Update Instructions

SP016/03/S

Title: Hardware Check Motor Drive

Reason for the Update

Fig. 1

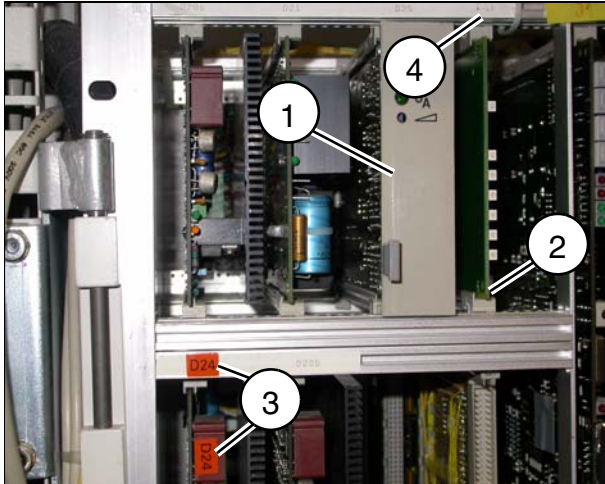
- Remove the board D25 (1/Fig. 1)
- Swivel out the control unit M20.
- Remove any EMC covers.
- Fasten the socket connector for board D23 at the slot next to board D25 (2/Fig. 1). Use the supplied slotted cap screws for this. If there are no threads available in the control frame, then use self-tapping screws M2.5 x 8 with Phillips head.
- Label the slot with D23 (4/Fig. 1).
- Attach guide rails.
- Plug board D25 back in.
- Check DIP switches on board D23. Switches 3, 4 and 6 must be "ON". The position of all other switches is arbitrary.
- Plug in board D23.

- Affix label D24 at position (3/Fig. 1).
- Cover old designation D20a on the frame with new label D24.

Fig. 2

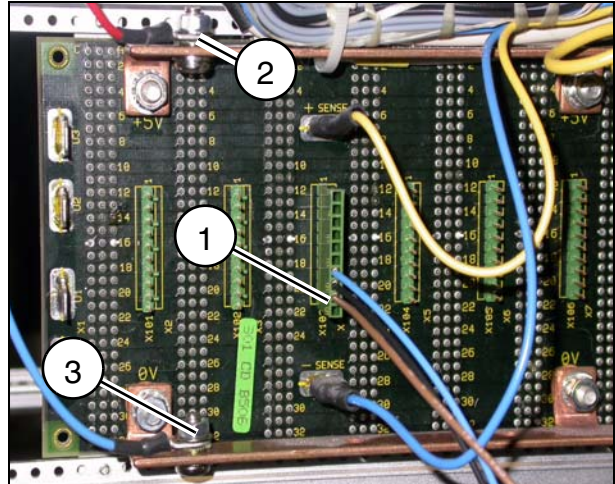
- Plug the brown lead from the socket connector D23 d8 into the 10-pin socket connector X103.9
- Screw fasten the red lead from socket connector D23 d2 onto the plus rail (2/Fig. 2)

- Screw fasten the blue lead from socket connector D23 d4 onto the minus rail (3/Fig. 2)
- Reattach the EMC covers, swivel in the control unit and fasten it with screws.

Fig. 3

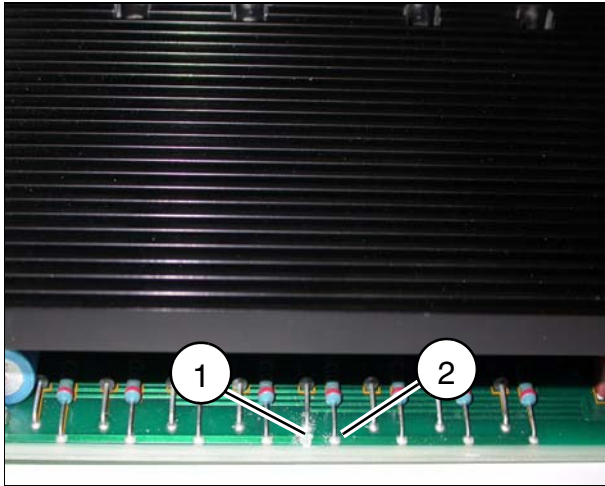
- Remove board D20a.
- Separate the connection from socket connector X1 b2 to b4 (1/Fig. 4) on the soldering side of the board and check the interruption with an ohmmeter.
- Interrupt connection between 4th and 5th resistor (1/Fig. 3) and check the interruption with an ohmmeter.
- Solder interconnecting wire 0.5 on board from socket connector X1 b4 (1/Fig. 4) to the 5th resistor (2/Fig. 3 and 2/Fig. 4) viewed from the socket connector.
- Stick label printed with the new part number 11 56 731 over the old part number 89 49 505 G5334 on board.

Fig. 5

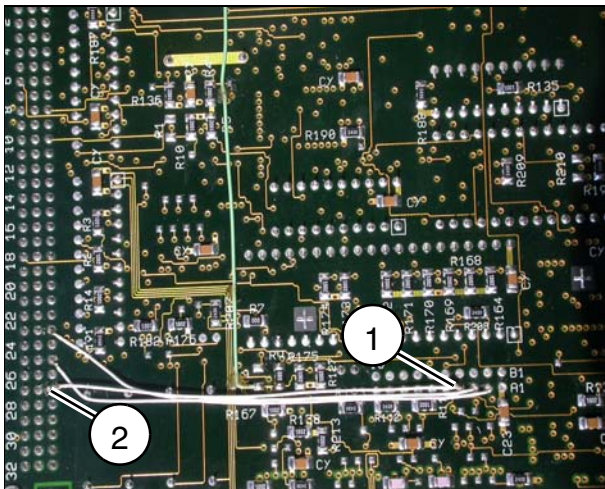
- On board D3 solder interconnecting wire 0.25 from X11 a4 (1/Fig. 5) to X2 c27 (2/Fig. 5).
